UTAH DEPARTMENT OF TRANSPORTATION

SUBJECT: Standards Committee Meeting Minutes and Next Meeting

October 25, 2007

Standards Committee Meeting

GRADE SEPARATED ARTERIAL
DESIGN SPEED 50 TO 60 MPH

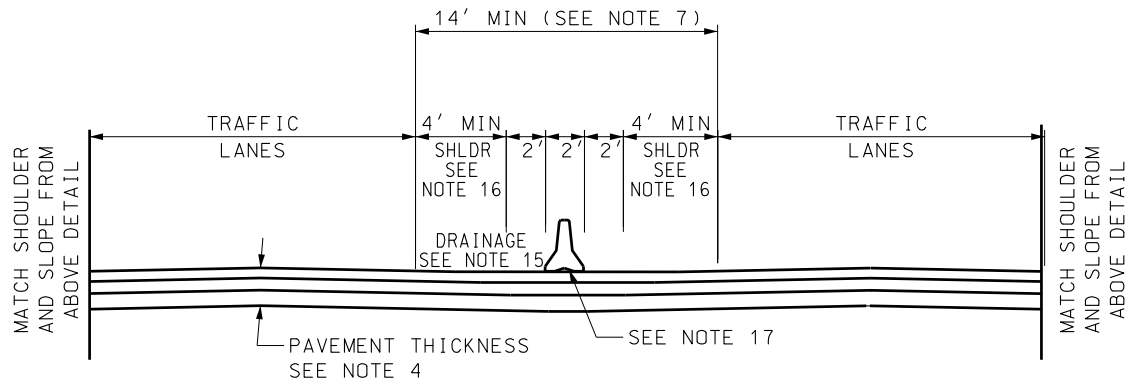
Item No.	Reviewer	Sheet/Section No.	Comment	Review Mtg. Action	Final Action.
1	Robert Westover, R3 Operations Engineer	DD 11A	No comments.		
			Response:		
2	Clark Mackay, R4 Construction Engineer	DD 11A	My comments deal with notes 14 and 15. "Algebraic differential' should be 'algebraic difference'. See AASHTO sheet 307 top of page. In note 14 you show a maximum of 6% AASHTO allows the algebraic difference to not exceed 8%. Do we want to match AASHTO or be tighter than AASHTO? Again see AASHTO sheet 307. The 'algebraic difference' correction should also apply to Std Dwg DD 4 notes 16 and 17 and Std Dwg DD 11 notes 15 and 16.

4	Clark Mackay, R4 Construction Engineer	DD 11A	As I look at Std Dwg DD 11, I am wondering if you are planning on removing the details that are going to be on sheet DD 11A? Should there be a new sheet DD 11?		
			Response: The two standards are similar in many ways, and we've considered merging the two drawings. However, there is enough dissimilarity to keep them separate for the time being. Many of the notes, much like with DD 4, will be the same for both drawings to prevent confusion.

Std Dwg/Spec Number		DD 11A		Sheet 4	of	7
Date:		April 2008		Facilitator:		Patrick Cowley
11	David Schwartz, R2 Resident Engineer	DD 11A	Aren't there only 3 acceptable positive separation methods at these speeds. Concrete barrier, Cable Barrier, and guardrail. I would just list them at this point.

Std Dwg/Spec Number		DD 11A		Sheet 6	of	7
Date:		April 2008		Facilitator:		Patrick Cowley
22	Tyler Yorgason, Standards Representative, ACEC	DD 11A	Is this different enough from DD 11 to have a separate drawing? Can the Undivided Median section and some changes to the notes just be added to that drawing?
